**SERVICE
BULLETIN
402
4 CYCLE**

SUBJECT: Procedure for Addressing High Altitude on OH Engines

MODELS OR TYPES AFFECTED: All Fixed Jet Walbro Carburetors on OH120 thru OH180 Engines.

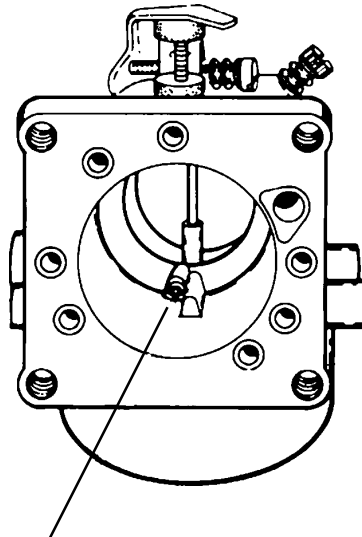
1. Remove air cleaner assy.
2. Remove choke shaft assy.
3. Using an ice pick type tool with a small hook on the end remove the brass cup plug out of the nozzle well vent.

NOTE: DO NOT USE A THREAD TAP AS CHIPS MAY ENTER THE CARBURETOR

4. Reassemble choke shaft assy.
5. Reinstall air cleaner assy.

REMOVE CHOKE LEVER ASSY.
NOTE BRASS CUP PLUG
